## Access Compliance Report Public Rights-of-Way (Curb Ramps)

Intersection ID: 13754 Main Street: S\_MCDOWELL\_ST Cross Street: BAXTER\_ST Location: SE

ADA ID: DEFF97B7EFFB Ramp Type: Combination2 Initial Pass/Fail: Fail Overall Compliance: No Severity Score: 25

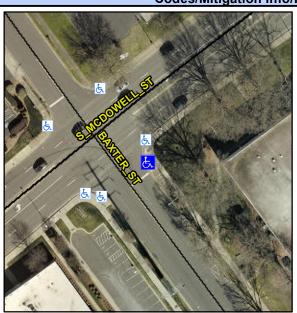
Not Found, R304.2.2, R304.5.3, R304.3.2

Remove & Replace Entire Ramp.
